# Access Compliance Report

## Public Rights-of-Way

Intersection ID: 28376	Main Street: GEORGIAN_HALL_DR	Cross Street: SOUTHAMPTON_COMMONS_DR	Location: SW
ADA ID: CA47C2362A9C	Ramp Type: PerpDiag	Initial Pass/Fail: Fail	Overall Compliance: No
		Severity Score: 25

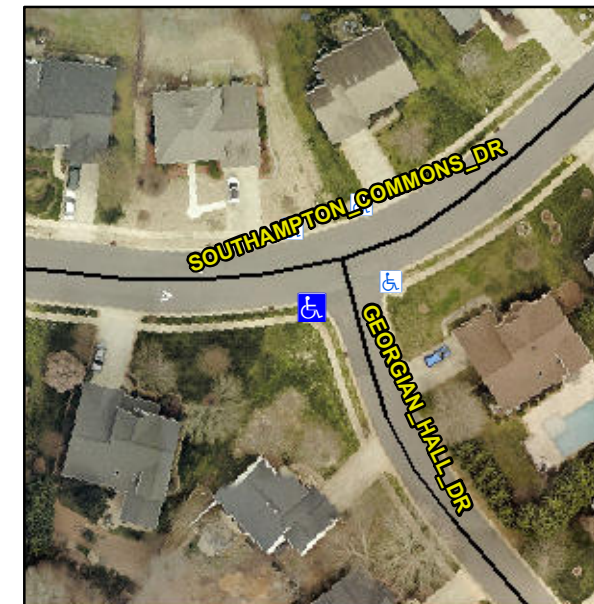
**Not Found, R304.5.3**

Compliance	Description	Data	Compliance	Description	Data
N/A	Ramp Length (in)	40.0	Yes	Ramp Slope (%)	5.5
Yes	Ramp Width (in)	48.0	No	Ramp XSlope (%)	7.7
N/A	Flare Type LT	N/A	N/A	Flare Type RT	N/A
N/A	Flare Slope LT (%)	N/A	N/A	Flare Slope RT (%)	N/A
N/A	Flare Traversable LT?	N/A	N/A	Flare Traversable RT?	N/A
N/A	Landing Length (in)	N/A	N/A	DWS Provided?	N/A
N/A	Landing Width (in)	N/A	N/A	DWS Contrast?	N/A
N/A	Landing Slope (%)	N/A	N/A	DWS Length (in)	N/A
N/A	Landing X Slope (%)	N/A	N/A	DWS Full Width?	N/A
N/A	Landing Curb? (Y/N)	N/A	N/A	DWS Offset (in)	N/A
N/A	Shared Landing?	N/A			
N/A	Gutter Ponding?	N/A	N/A	Gutter Slope (%)	N/A
N/A	Gutter Lip Ht (in)	N/A	N/A	Gutter X Slope (%)	N/A
N/A	Painted X Walk1?	No	N/A	Painted X Walk2?	No
	X Walk 1 Direction	To E		X Walk 2 Direction	To N
N/A	X Walk 1 Width (in)	N/A	N/A	X Walk 2 Width (in)	N/A
	X Walk 1 Slope (%)	6.8		X Walk 2 Slope (%)	4.1
	X Walk 1 X Slope (%)	0.8		X Walk 2 X Slope (%)	4.3

**Remove & Replace Curb Ramp With Two New Directional Ramps or Equivalent.**
